REMARKS

The Office further rejects claims 27-44, 47, 48, 51-54, and 64-68 pursuant to 35 U.S.C. 102(b) as being anticipated by Vaillencourt et al (US 5,341,946). The Applicant disagrees and respectfully traverses this rejection.

The Office further rejects claims 27-42, 47, 48, 51-54, 64-68, and 71-80 pursuant to 35 U.S.C 102(e) as being anticipated by Krishnahumar et al (US 5,971,184). The Applicant respectfully disagrees and traverses this rejection.

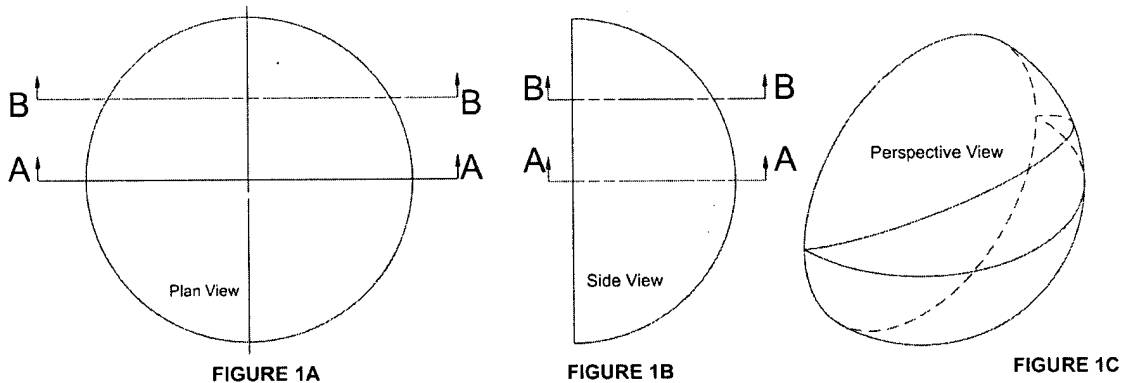
Regarding claim 47 and 48, both Claims 47 and 48 have been amended, and it is contended that Figure 9 does not claim to show any equivalent structures that undergo 'progressive' deflection in the manner performed by the present invention. The simple structures of Vaillencourt may well undergo progressive deflection, but this is not claimed nor shown to occur within Vaillencourt. Nevertheless, it is contended that the structures are entirely different and operate in a different manner and to different effect.

FIGURE 2

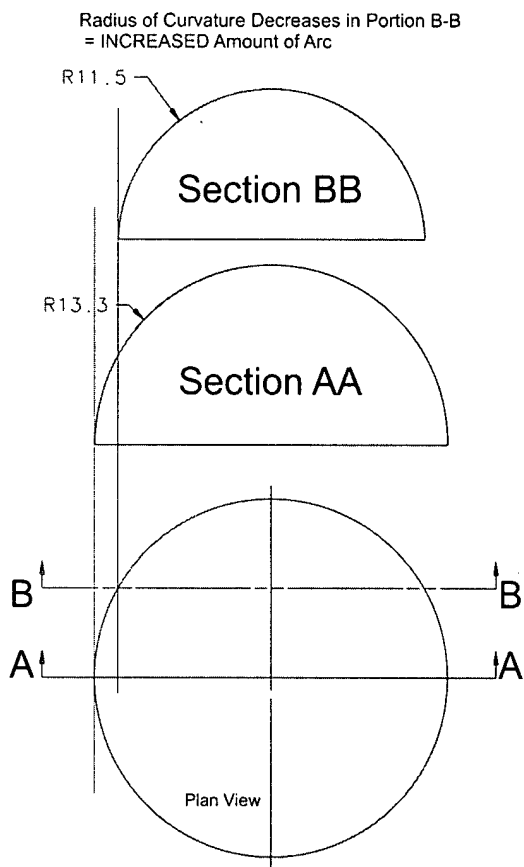
Referring to Figures 1a-c above, a panel surface that is completely convex in both the vertical and horizontal, ie a dome as shown in perspective in Figure 1c, will have a curvature relative to the vacuum panel plane (viewed in cross-section in Fig 2). Figure 1a is a plan view of the panel, parallel to the longitudinal axis and the plane of the vacuum panel. The transverse plane runs parallel to lines A-A and B-B, and defines perpendicular cross-sections of the panel and container.

A cross-section taken through the middle of the panel (A-A) in the transverse direction yields a certain amount of arc (shown in cross-section in Figure 2 below). A

cross-section taken longitudinally away from this (B-B) yields a different amount of arc (shown in cross-section in figure 2 below).

As illustrated in Figures 1 and 2 above and below, even though the portion of a double convex panel taken through line B-B is less outwardly projecting, it will actually possess a stronger amount of arc. For the perfect dome shown in these illustrations, the radius of curvature at section B-B is 11.5, whereas at Section A-A it is 13.3. Thus, Section B-B, while outwardly projecting to a lesser extent, actually has a lower radius of curvature, meaning the amount of arc is greater than at Section A-A.

FIGURE 3
(Krishnakumar Fig 1)

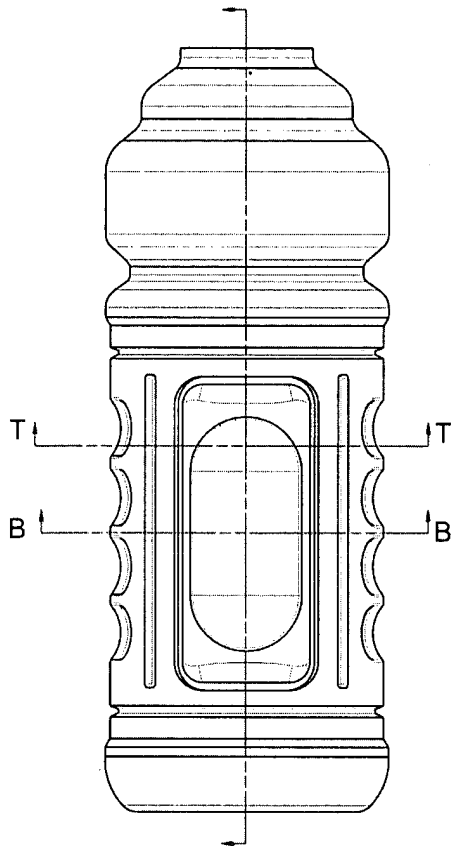
Krishnakumar discloses a vacuum panel that is convex in both the longitudinal and transverse extents. It is a double convex structure, although not as convex as the dome illustrated above. Despite this, the disclosed regions of less outward projection do not

comprise an amount of arc that is *less* than in the flexure region, as required by claim 27 (“said flexure initiator region having a lesser amount of arc...than said flexure region”).

FIGURE 4
(Krishnakumar Fig 2)

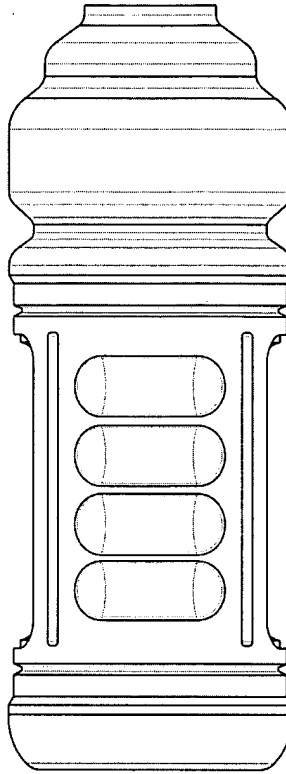
Comparing the amount of arc contained within the flexure region (B-B) and the region of less outward projection (T-T) reveals that by lowering the convexity of the double curvature to a minimum, the less outwardly projecting portion (T-T) still maintains an amount of arc equal to the flexure region.

FIGURE 5
(Krishnakumar Fig 6)

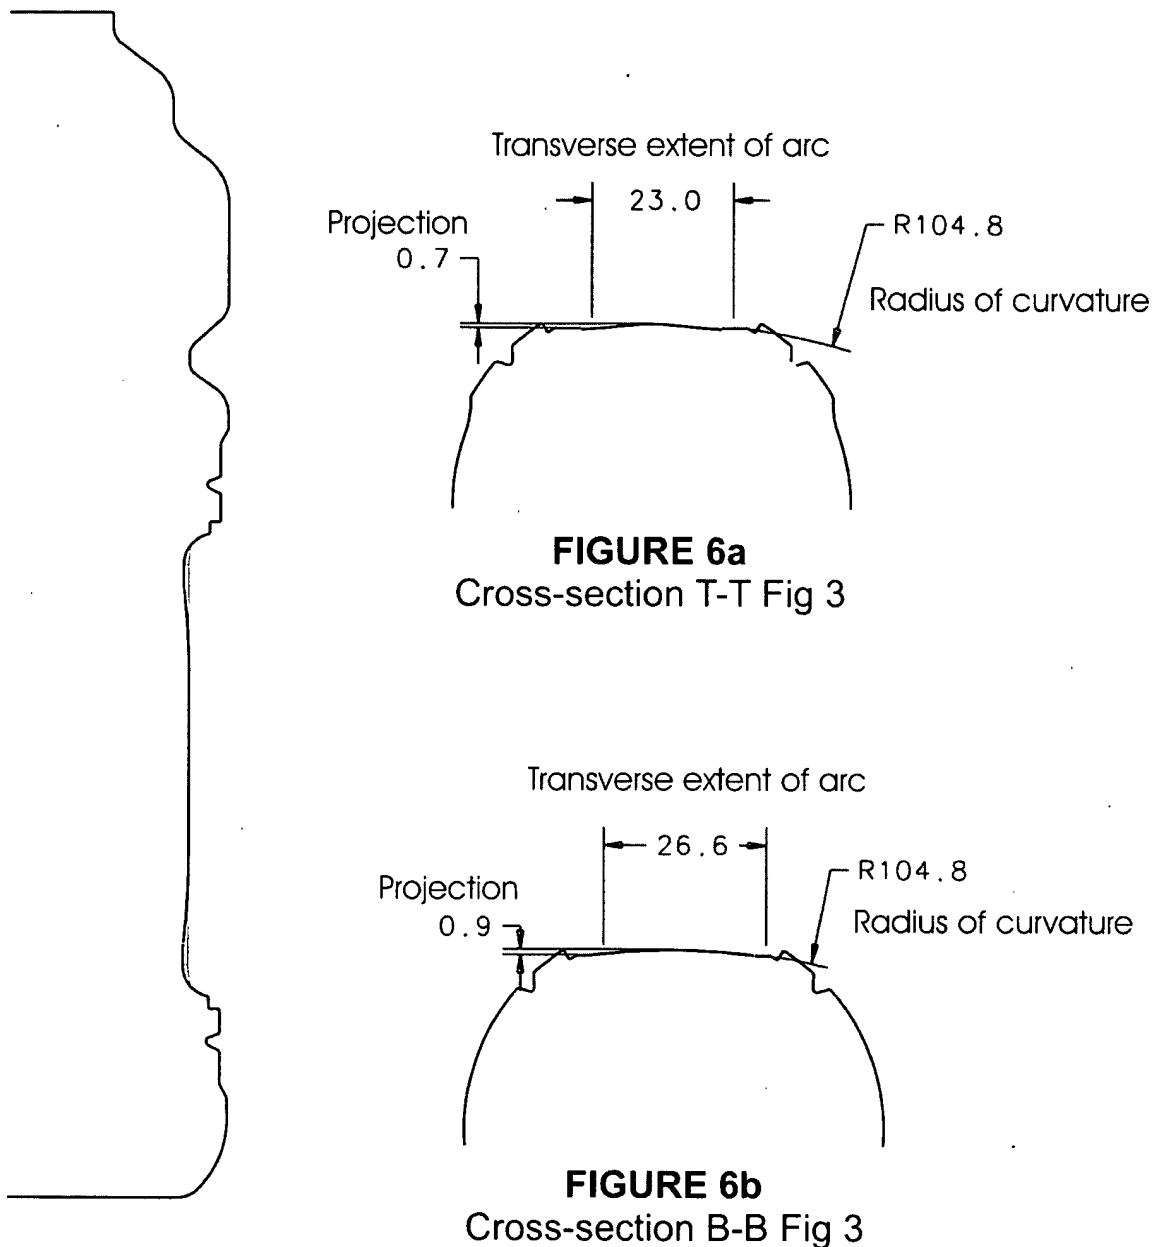
Referring to Figures 6a and 6b below, the cross-section at T-T is less outwardly projecting but has the *same* radius of curvature in order to create the panel shown, whereby the transverse extent of arc closes off in the manner illustrated in Figures 1 and 7 of the Krishnakumar patent citation.

FIG. 9

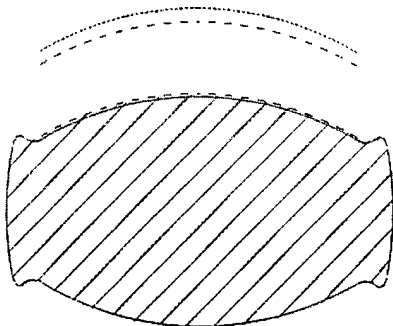
Referring to Figures 5-9, the claimed structures are not shown. Figure 8 shows a transverse section through the vacuum panel of Figure 5 of Weckman, at line 8-8, near the lead line 92. Figure 9 shows a transverse section through the vacuum panel of Figure 5 of Weckman at line 9-9. The outward curvatures shown in Figure 8 and in Figure 9 have the same amount of arc. An optical illusion creates the impression that the amount of arc contained in Figure 8 appears to be less than the amount of arc contained in Figure 9. However, this is not the case, or a label could not be applied to the panel.

An expanded view of both curvatures shown in Figures 8 and 9 of Weckman reveals that the panel contains the same amount of arc. Figure 8 is shown above Figure 9. The smaller dotted line shows the curvature of Figure 8 and the larger dotted line shows the curvature of Figure 9. They are repeated adjacent to each other to show how they are derived from the same radius of curvature, and therefore have the same amount of arc, even though they are transversely radiating to different degrees.
